INCH-POUND
MIL-PRF-22885/15D
25 April 1975
SUPERSEDING
MIL-S-22885/15C
31 August 1970

PERFORMANCE SPECIFICATION SHEET

SWITCHES, PUSH, ILLUMINATED, 4 - LAMP, CLIP MOUNTED

FIGURE 1. Switch, push, illuminated, 4-lamp clip mounted (modular constructed) .

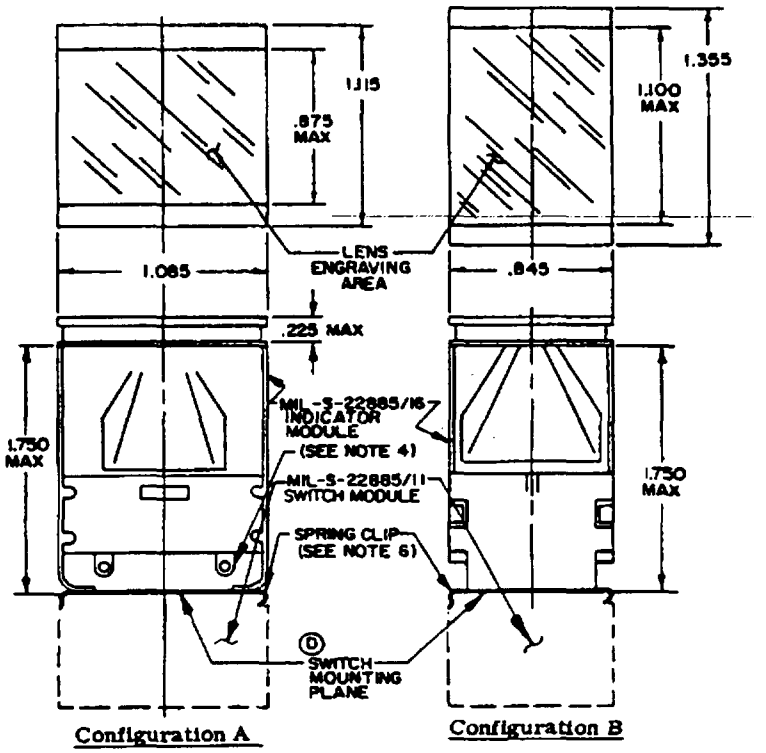
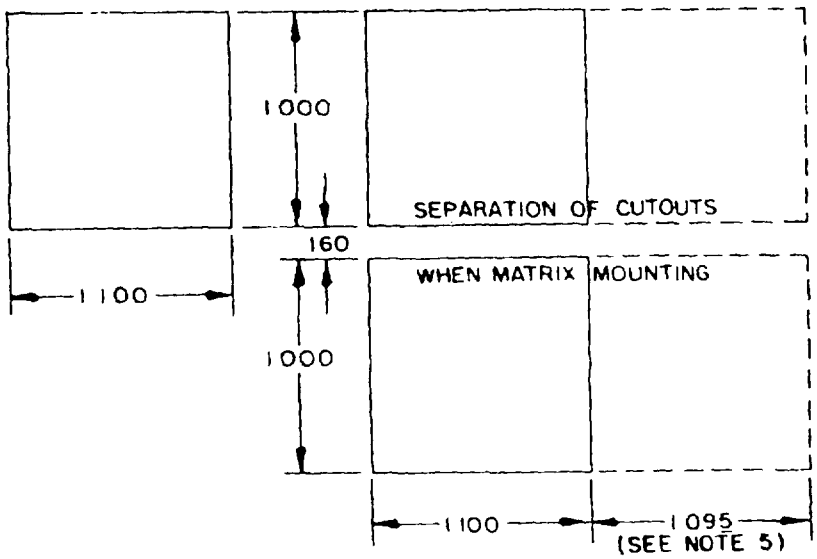
NOTES:
1. Dimensions are in inches.
2. Unless otherwise specified, tolerances are ±.016 (.41 mm) and ±.02 (.51 mm).
3. The design configuration is optional within envelope dimensions shown.
4. Terminal design is optional.
5. Metric equivalents (to the nearest ,01 mm) are given for general information only and are based upon 1 inch = 25.4 mm.
6. (D) Switch clip design optional - must interface with MIL-S-22885/11 switch modules.
